KENNEBUNKPORT ZONING BOARD OF APPEALS
Administrative Appeal Application

Reason for Appeal: Lifting of Suspension of Permits without all corrective measures ordered being taken:

Narrative Addendum to Slager ZBA Appeal dated 3/23/2020

Resubmitted Plot Plan

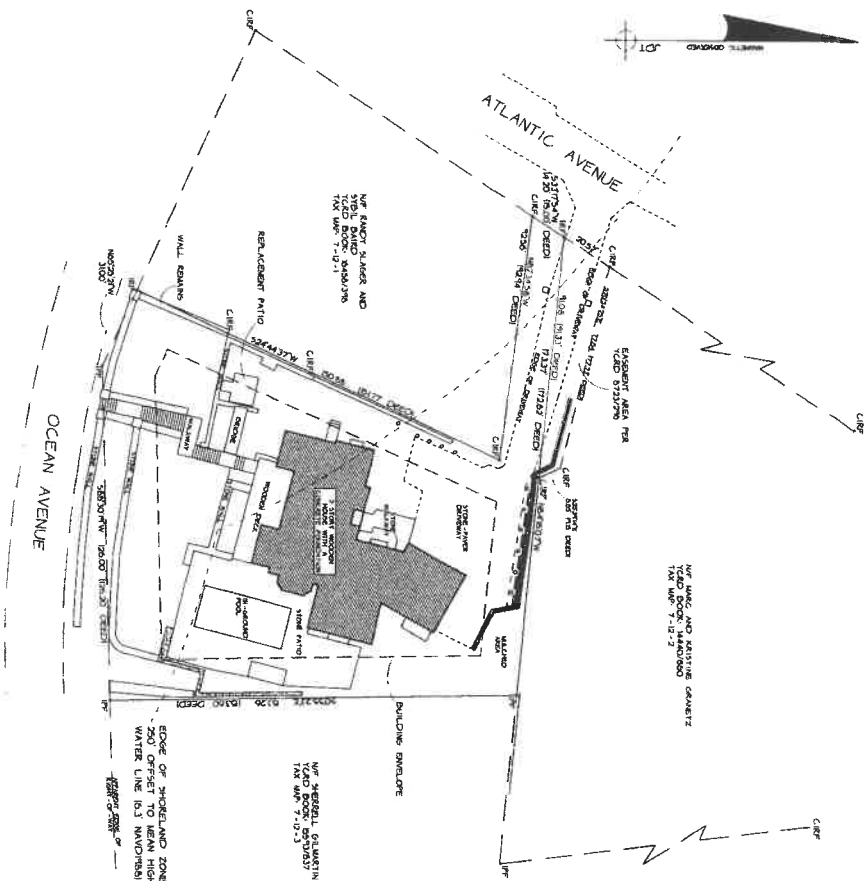
The CEO, who has been on the site, must have been aware that the small area depicted as “replacement patio” on the Resubmitted Plot plan does not correctly represent the nonvegetative surface area of the expanded raised patio structure as it currently exists. The area shown on the Resubmitted Plot Plan *as vegetated area* is currently all gravel and/or concrete, as shown on photographs submitted herewith taken from Mr. Slager’s 2nd floor bedroom window. The nonvegetative surface calculations on the Resubmitted Plot Plan do not reflect the increased impervious lot coverage attributable to the expanded raised patio area. Perhaps the CEO excused this discrepancy because the Tompkins plan called for planters to be located on top of the gravel patio structure, relying on a bogus claim that Bell can deduct those portions of the top layer of the new structure on which planters are to be placed.⁶ The Resubmitted Plot Plan also fails account for the increased nonvegetative surface areas occupied by walls A1 and A2. The CEO erred in accepting the Resubmitted Plot Plan as adequately complying with the corrective actions required by the Suspension Order because the as-built construction clearly does not match what is shown on the plan thereby making the nonvegetative surface calculations incorrect.

Moreover, the Resubmitted Plot Plan accepted by the CEO does not meet the resubmission requirement of “an updated lot coverage break down for review” mandated by the Suspension Order. It omits dimensional figures and calculations of coverage from the plot plan itself, thereby obscuring the actual calculations of lot coverage recited on the tables. The CEO’s letter of February 28, 2020 does not explain how the CEO was able to rely on the Resubmitted Plot Plan to determine current nonvegetative surface coverage, for which a variance appeal as to lot coverage is required. (*See*, Ordinance § 8.3.⁷) (In fact, the new gravel structure as-built, is a nonconforming structure as to lot coverage, height for a patio, and setback as both a patio and a structure, for which a variance is required!)

1. Resubmitted plot plan does not adequately show updated lot coverage.
 - a. The Resubmitted Plot Plan does not depict *on the plan itself* area borders and dimensions, with comprehensible updated lot coverage break down for review;
 - b. Calculation of lot area coverage does not appear to include the entire area of all structures on the lot, and in the Shoreland area, where Ms. Bell appears to

improperly exclude areas of gravel structure where planters may be located in future from lot area coverage, which appears to exceed the 44% limitation on nonvegetative surface coverage

15 TYPICAL DRY-STACKED WALL DETAIL

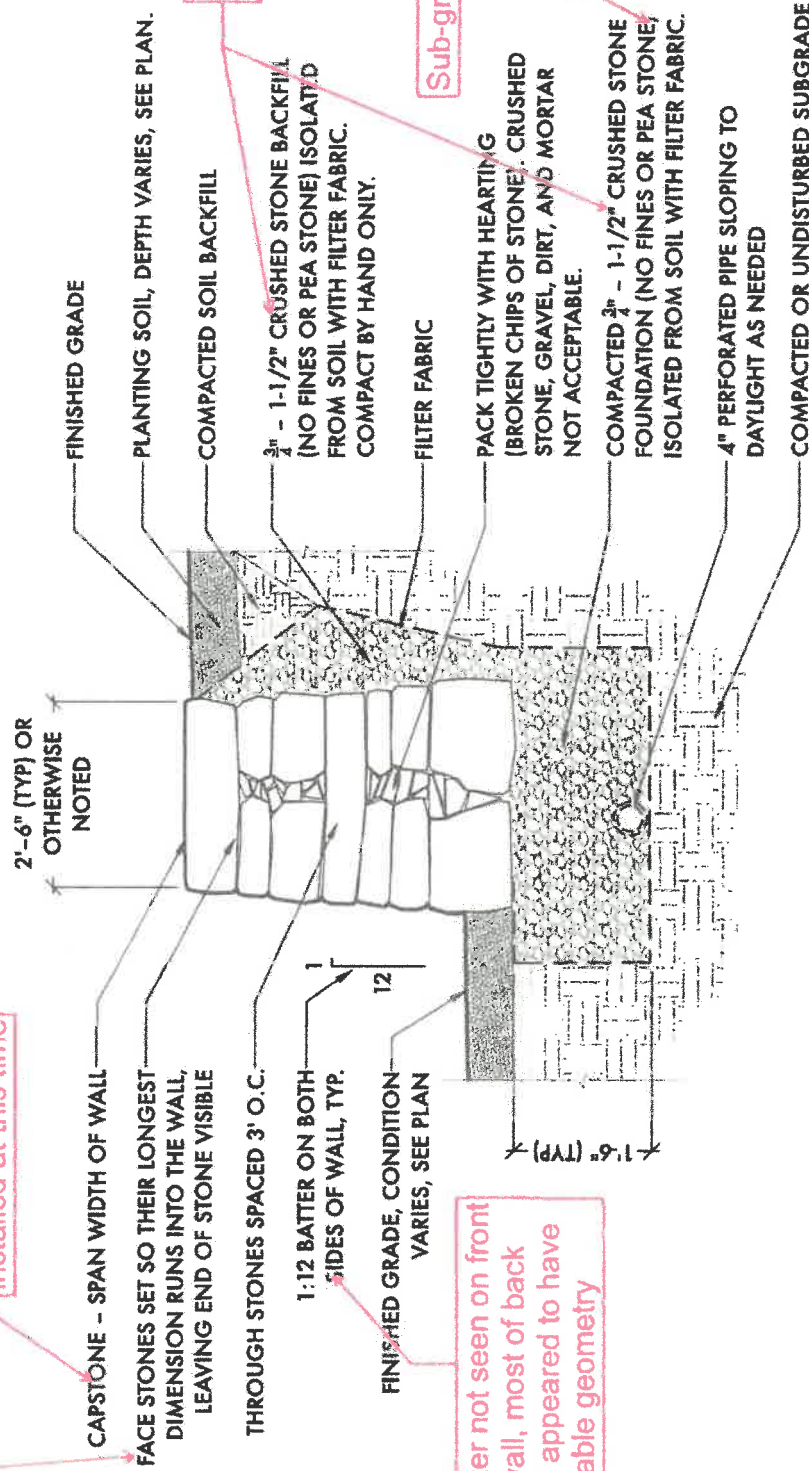
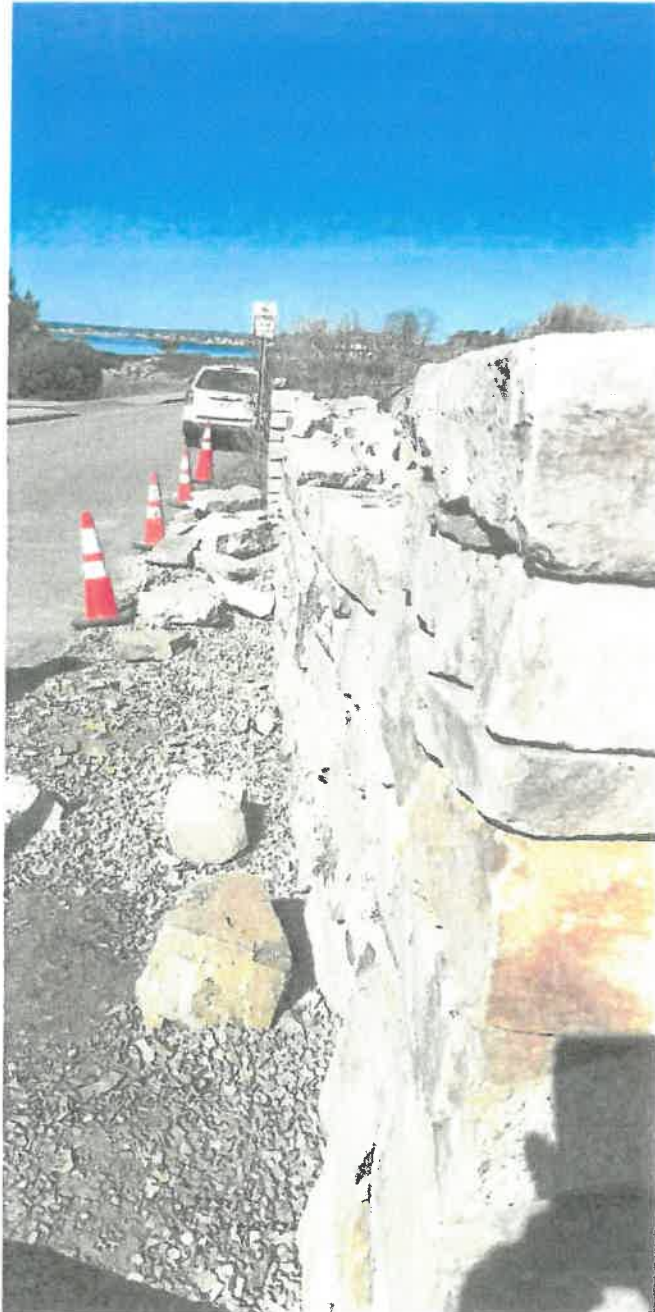
was based on typical detail 15 on sheet L-4.0. When I observed the conditions on site, I found several items that did not match the typical detail on sheet L-4.0. I have attached a marked up copy of the detail to show the items the do not match and the following photos of the in-place wall built with the noted inconsistencies. It appears evident that the current construction to the walls does not match the intent of the typical detail for their construction

Items Not Per Detail

No full capstones installed at this time

Batter not seen on front of wall, most of back wall appeared to have variable geometry

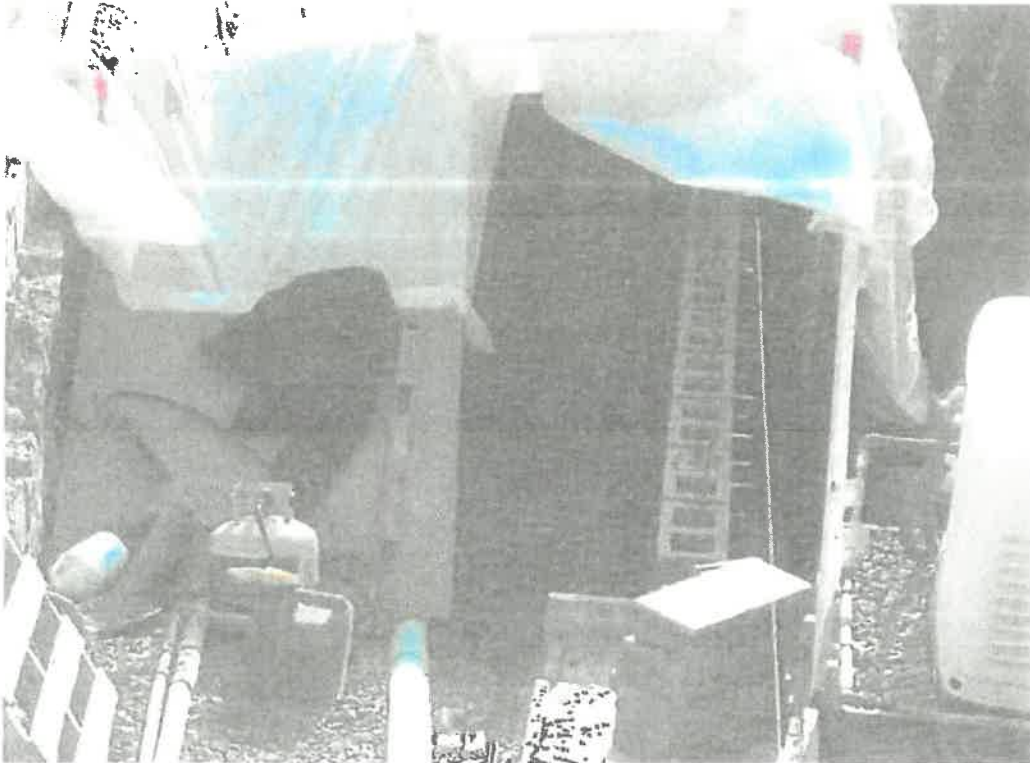
Photo #14 (by others) – View looking south. Concrete masonry block appears to have metal tie connectors at right side. Metal tie connectors are often used to connect stone veneer to CMU walls. Also note there appears to be vertical steel reinforcement inside the CMU vertical cells. Most of the bars are near the center of the core, but some are toward the west side of the cell (which reduces strength).

Individuals present during the 11/11/19 site visit included Randy Slager (home owner) and David Price, P.E. The purpose of the second site visit was to:

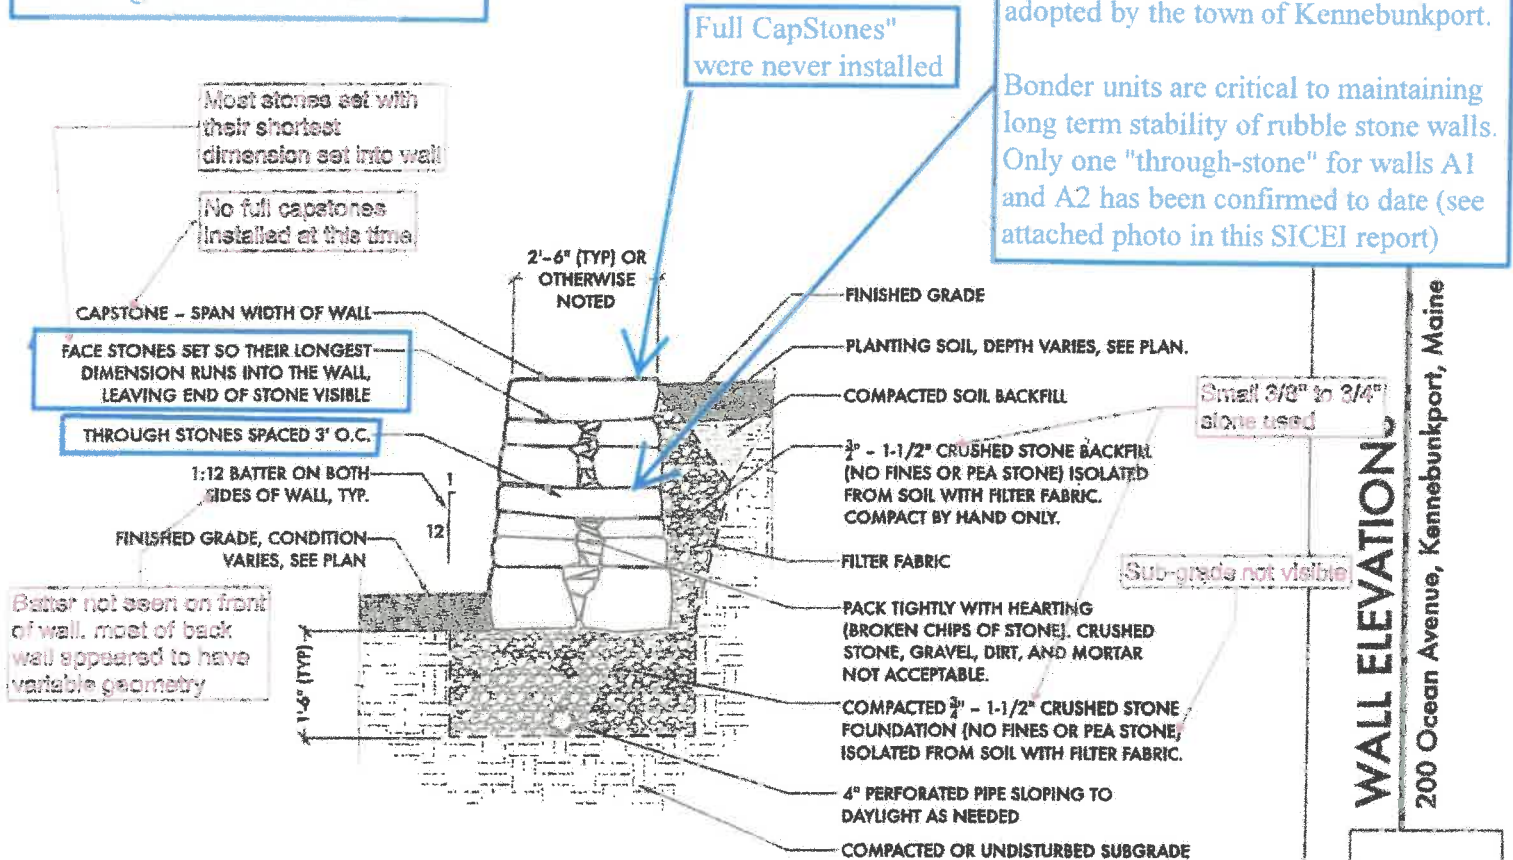
The opinions expressed within this report are based on the following:

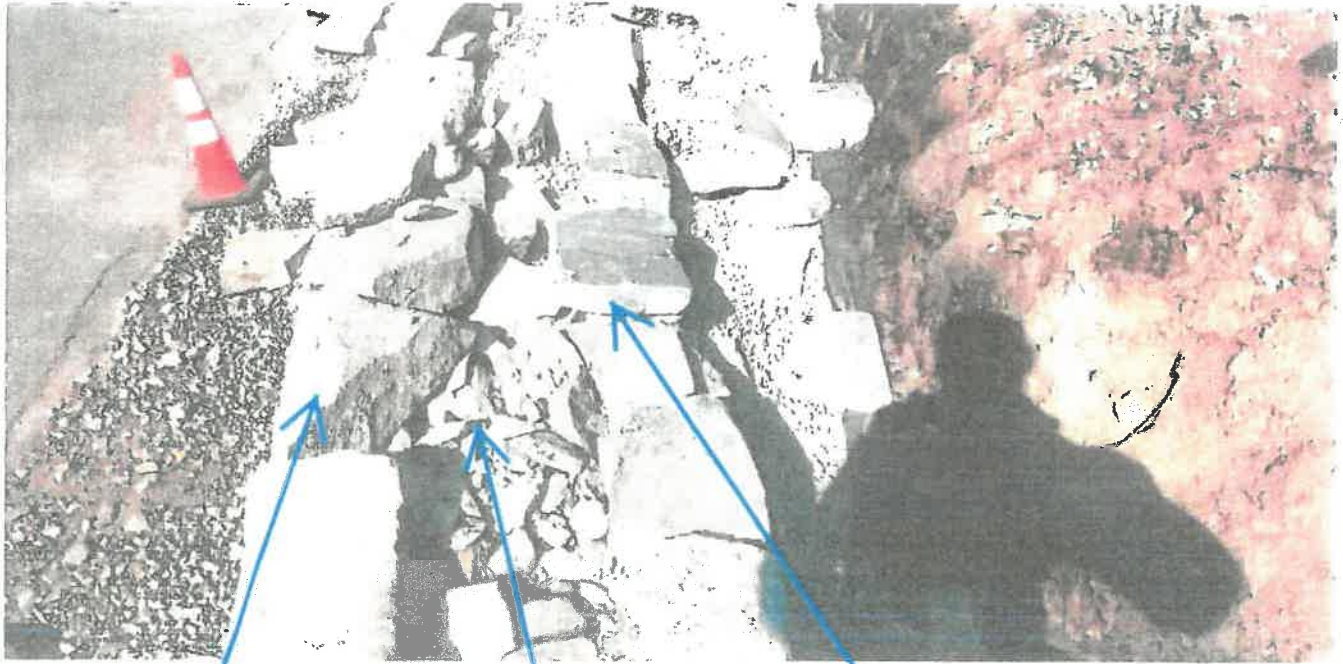
- d. His situation is that he spends the winter at his Florida residence, normally from middle of October to middle of May.
- e. Lori purposely waited until after he left for the winter to give him notice about her changes in construction at the property line.
